## Report of the Chief Planning Officer

### NORTH & EAST PLANS PANEL

**Subject: APPLICATION 14/05152/FU – Retrospective application for amendments to previously approved application 13/00563/FU ( single storey front, side and rear extension) –alterations to eaves height, amendments to windows and doors, amendments to internal layout to include attic rooms, new solid roof to form porch canopy to front and new outbuilding to rear of 6 Roper Avenue LS8.**

## Site Plans (existing and proposed)

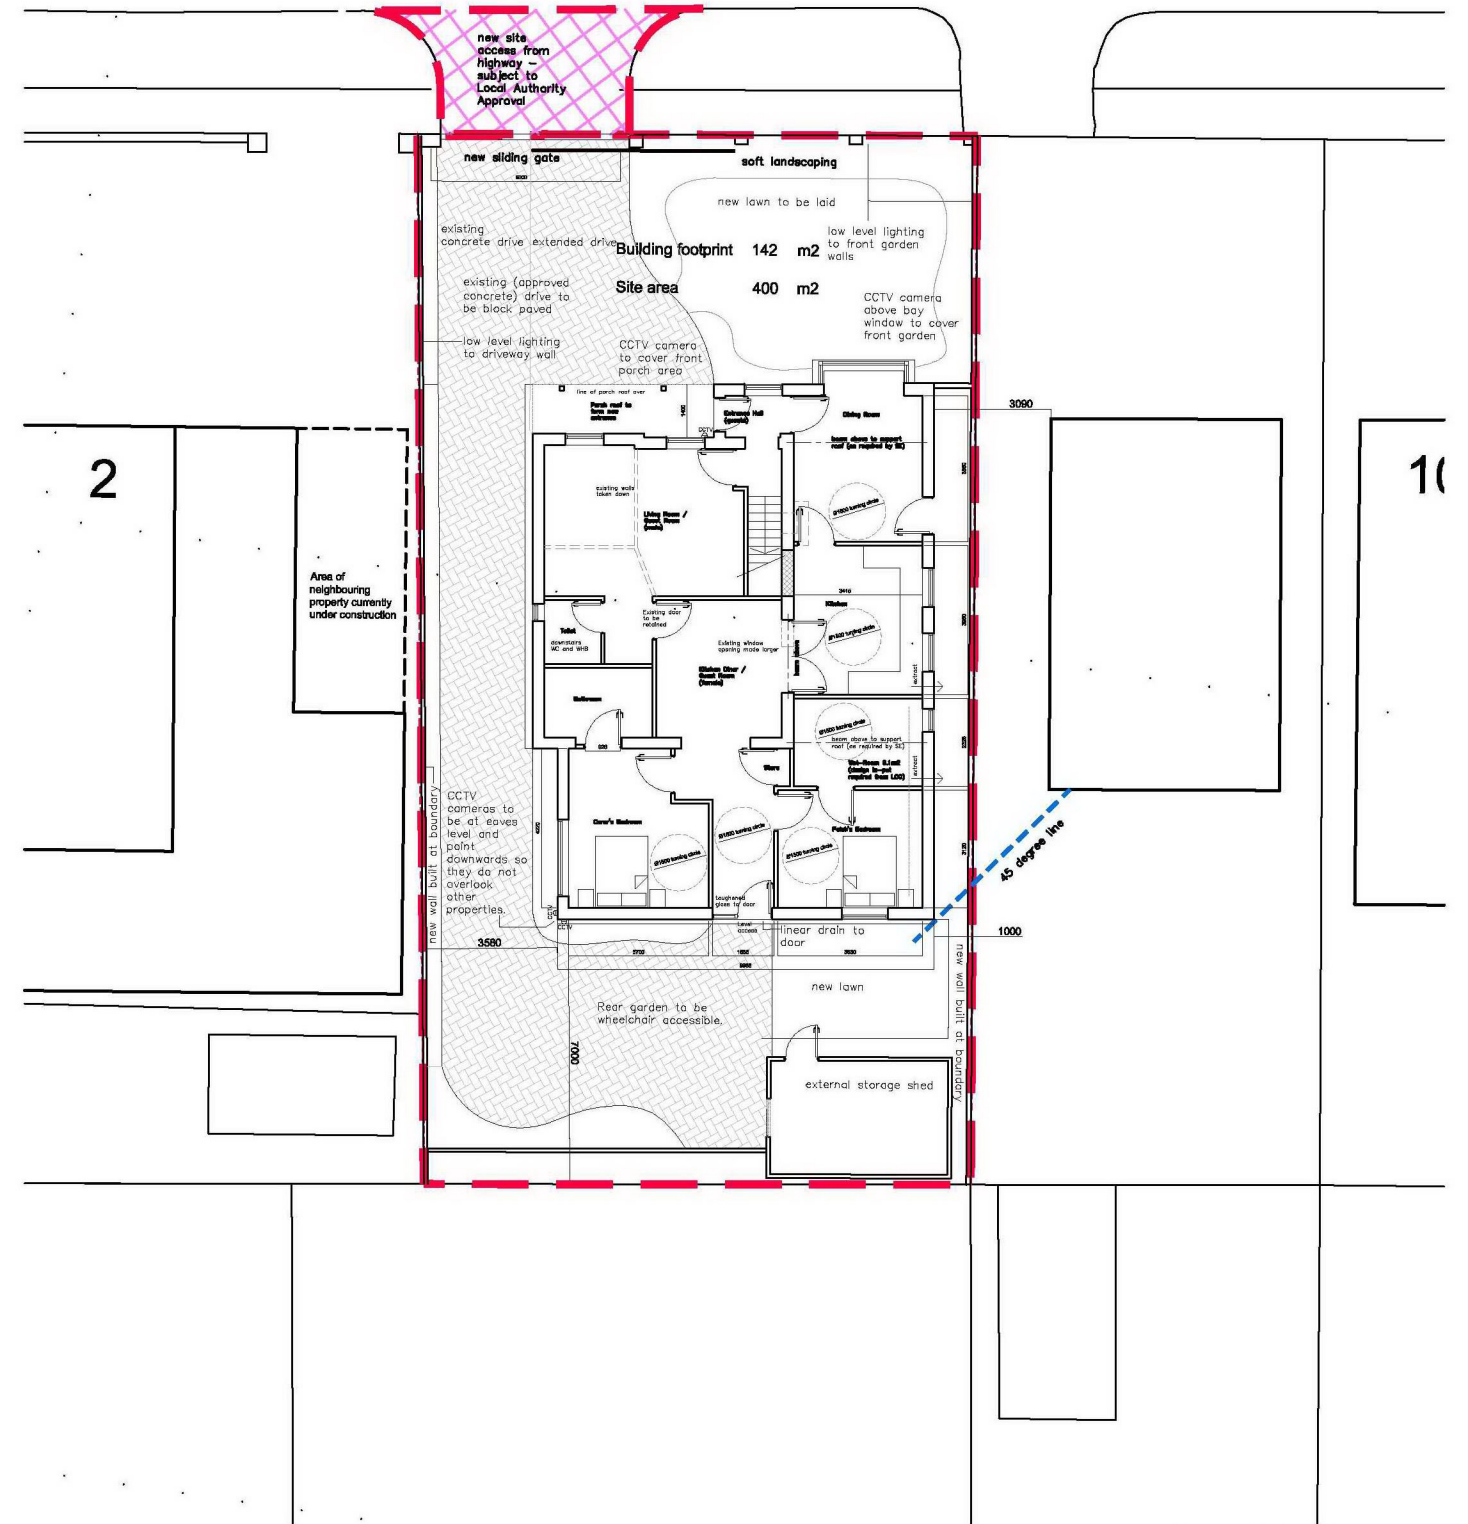
- 1.3 Subsequent to the last Plans Panel the applicant has submitted revised plans in an attempt to address the concerns raised at the November Plans Panel. The proposed changes are summarised as follows:

- (1) Front bay window – it is proposed to change the roof tiles to ones with a flat profile. This means that the heavy looking ridge tiles that currently are used to turn the corner on the hips of the bay window roof can be replaced with tiles that seamlessly turn the corner. This will give the roof to the bay window a more lightweight and refined appearance.

- (2) Front Porch - the roof canopy to the front porch is to be removed and the existing roof slope to be extended and continued forwards to form an overhang. The supports to this overhang are to be set in from the edge of the roof and decorative metal brackets are to be used to join the roof with the supports.

- (3) Garden Wall - the height of the garden wall to the end of the side access to be reduced in height by 1 block course together with the side boundary wall.
